REF: S24-0016
DATE: January 16, 2025

- Request - Preliminary Drawing for Fieldview Addition Being a Replat of Gardenview Acres Lot 1
- Location - 0 Greystone Parkway
- Applicant - Deon Davis
2460 N. Reynolds Road
Toledo, OH 43615
- Surveyor / Engineer - Lewandowski Engineers, A Verdantas Company
219 S. Erie Street
Toledo, OH 43604

PRELIMINARY PLAT
TOLEDO CITY PLAN COMMISSION
REF: S24-0016
DATE: January 16, 2025
TIME: 2:00 P.M.

PRELIMINARY DRAWING OF:
FIELDVIEW ADDITION
BEING A REPLAT OF
GARDENVIEW ACRES
LOT 1
CITY OF TOLEDO, LUCAS COUNTY, OHIO

PRELIMINARY PLAT

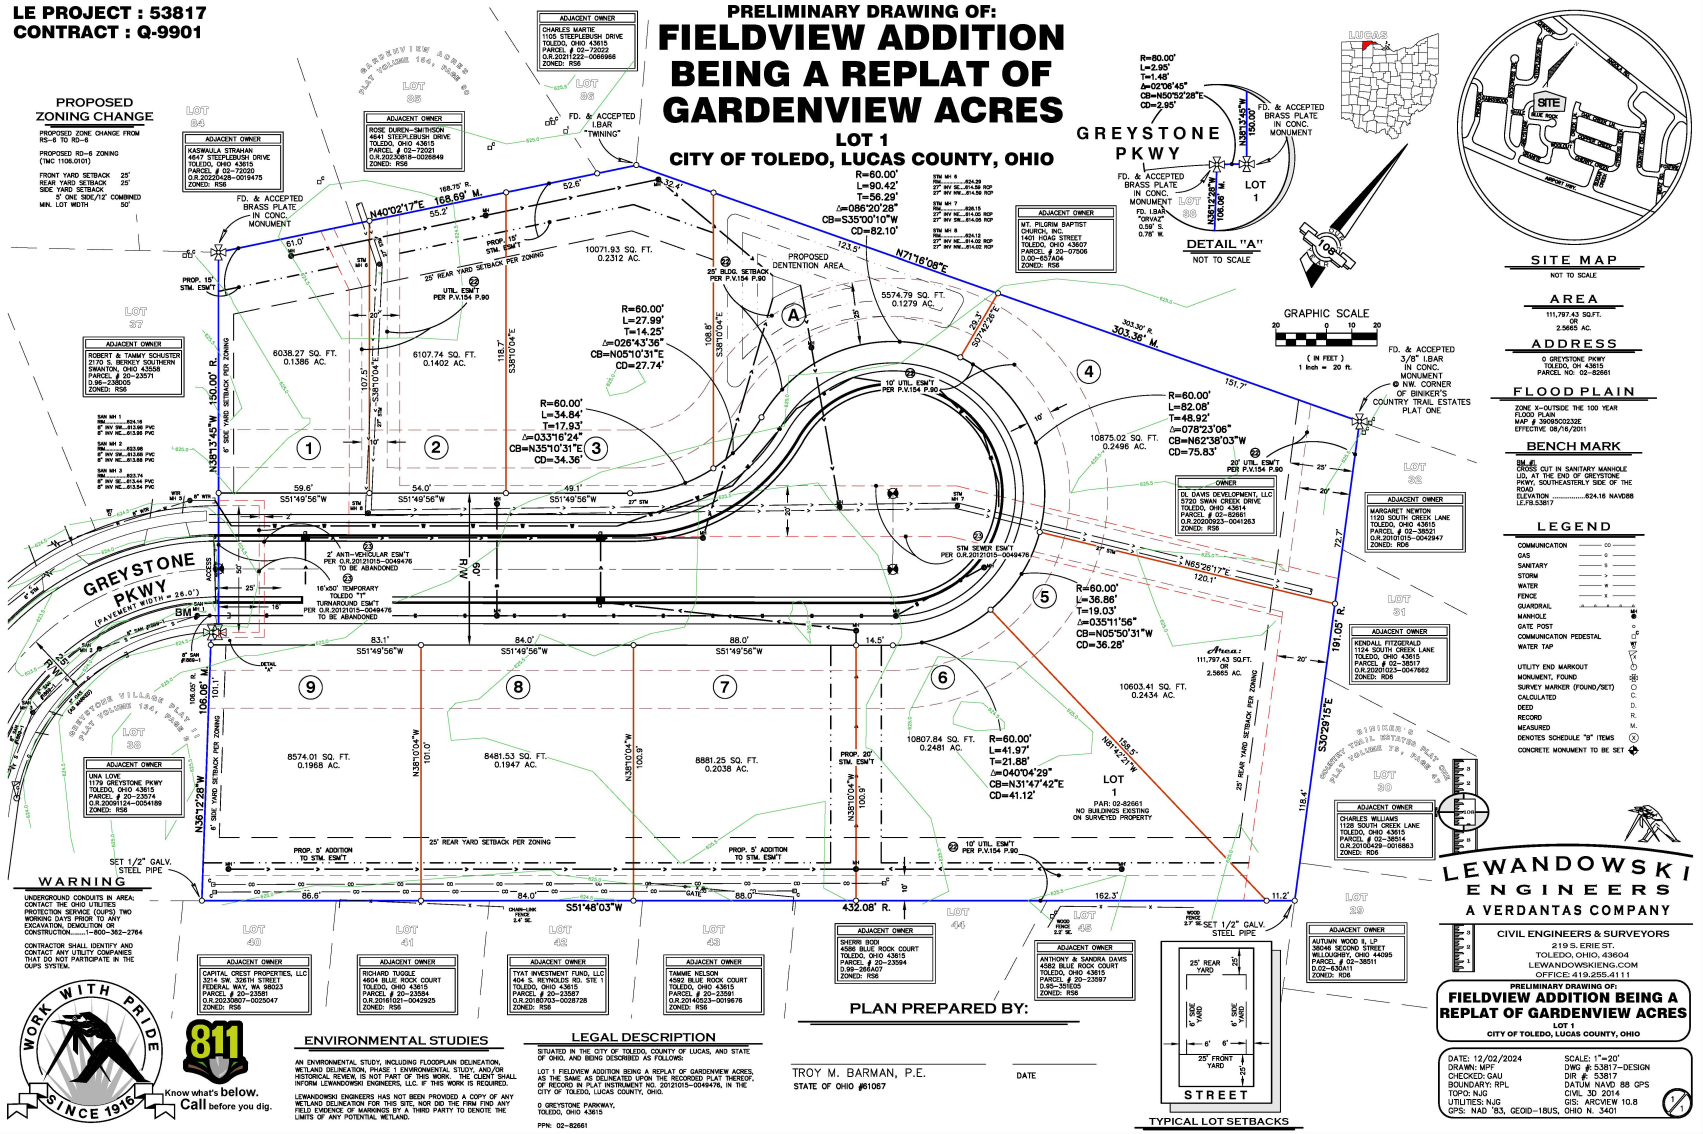
5. Water service for this development is available subject to the Rules and Regulations of the Department of Public Utilities.
6. Maintain a minimum of 10 feet of clearance between the proposed water main and proposed storm and sanitary sewers. Maintain a minimum of 10 feet of clearance between proposed hydrants and proposed storm and sanitary sewers.

7. The stormwater planning is adequate for a preliminary plat, although Toledo has not received engineering work by which it could be confirmed that the proposed detention will suffice for stormwater management needs. Confirmation is recommended prior to the final plat. The basin design shall conform the Toledo Infrastructure Standards and Ohio CGP and it shall be drained by gravity unless a defense is made and accepted that a pump must be used. Should any stormwater landscape changes be made in the process of receiving engineering approval, further coordination with the Plan Commission may be required to receive engineering approval.

8. Shared private storm lines within the subdivision shall have accompanying private easements shown on the plat.
9. Sanitary sewer service for this development is available subject to the Rules and Regulations of the Department of Public Utilities.
10. Sanitary sewer shall be completely within the proposed right-of-way. Sanitary sewer shall be a minimum of 10 feet inside of the proposed right-of-way.
11. Each lot shall have a separate sanitary sewer tap from the main line.

12. Markups on the preliminary drawing submitted by the Chief Surveyor on 12/11/24 shall be addressed on the final plat.

13. A Fire Hydrant is required to be placed on the extension of Greystone Pkwy. The closest fire hydrant is on Greystone at Shale Lane, which puts the end of Greystone Pkwy addition at 500 feet from the closest hydrant. Toledo Municipal Code requires a hydrant within 350 feet and the Ohio Fire Code requires a hydrant within 400 feet. (OFC 507.1 and 507.5.1, TMC 1511.03, rule 5, #1)

15. The east-west portion of the proposed right-of-way shall be an extension of Greystone Parkway and shall be named as such on the Final Plat. Street addresses shall be assigned by the Division of Engineering Services.

16. The location of utility line easements shall be subject to approval by the various utility providers and shall be a minimum width of ten feet (10’).
